Office Action Summary

10/563,954

PFEIFFER, WERNER

DETAILED ACTION

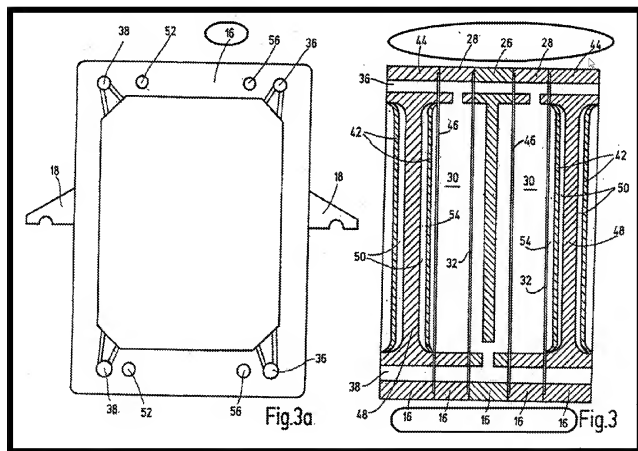
The recitation ***“arranged in sets thereof”*** does not appear in the originally filed specification. Moreover, referencing the specification and drawings to ascertain the meaning of this recitation in the context claimed revealed the use of the same reference numerals to designate the same part as outlined below.

The recitation ***“arranged in sets thereof”*** does not appear in the originally filed specification. Moreover, referencing the specification and drawings to ascertain the meaning of this recitation in the context claimed revealed the use of the same reference numerals to designate the same part as outlined below.

Support in the originally filed specification could not be found for the recitation, ***“feeding a washing fluid sequentially through each set of the second filter mediums, the filter cakes and the laminar filters in that order.”*** In this regard, the drawings and specification were of little help, as the flowpaths now claimed are not depicted.

Saito Patent with Arrows Clearly Depicting Flowpaths

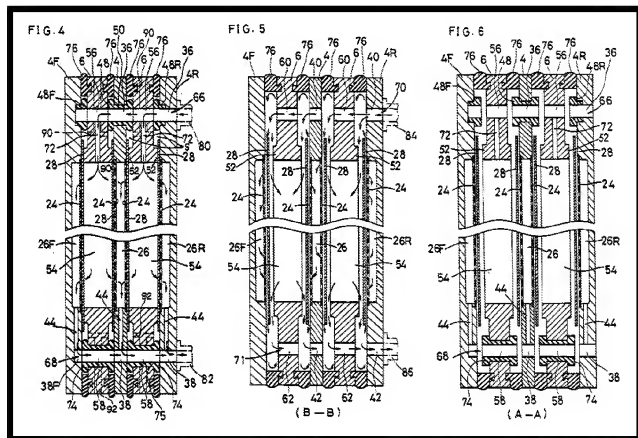
The drawings are objected to as failing to comply with 37 CFR 1.84(p)(4) because reference characters **"44," "28," "26" and "16"** have all been used to designate the same part:

The drawings are objected to under 37 CFR 1.83(a). The drawings must show every feature of the invention specified in the claims. Therefore, the claimed flowpaths must be shown or the feature(s) canceled from the claim(s). Note the arrows depicting the flowpaths in the illustrations of SAITO (US 5,362,387) below. No new matter may be entered.

Corrected drawing sheets in compliance with 37 CFR 1.121(d) are required in reply to the Office action to avoid abandonment of the application. Any amended replacement drawing sheet should include all of the figures appearing on the immediate prior version of the sheet, even if only one figure is being amended. Each drawing sheet
